Planning & Zoning Workshop

Unified Development Code Policy Amendments

August 14, 2025

Cul-De-Sac Exception Example

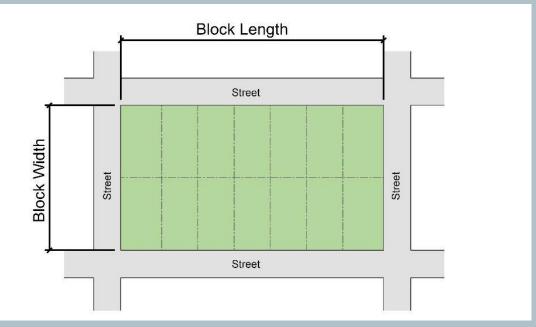
What is the problem: Lots served by private well and/or private septic are required to have a minimum street frontage of 150 feet or 200 feet. Clarification is needed regarding minimum street frontage along cul-de-sacs.

Council Direction: Provide a recommendation for street cul-de-sac street frontage.

Proposed UDC Amendment: The minimum is 100-feet for lots on a cul-de-sac or knuckle-sac.
